CSN 760

Customer Service Notice

Rotation Bearing Cap Screw Inspection

NHTSA Safety Recall
No. 20V-282

Figure 1 — 5185 Head Marking

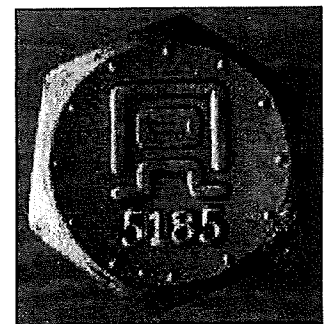
Look at the cap screw heads in the specified rotation bearing race(s) for a 5185 marking below the Altec logo (refer to Figure 1). Perform the following action(s) based on the inspection.

- If any cap screws in the race are broken, remove the unit from service immediately and replace all the cap screws in that race.
- If any cap screws in the race have the 5185 head marking and no cap screws are broken, replace all the cap screws in that race no later than the next regular maintenance interval or 90 days from the receipt of this CSN, whichever comes first.

- If none of the cap screws in the race have the 5185 head marking and no cap screws are broken, the inspection is complete on that race. If none of the cap screws in the race have the 5185 head marking, complete the Inspection Sheet at the end of this CSN and return it to Altec after the inspection is completed on the outer race of aerial devices and on both races of derricks.
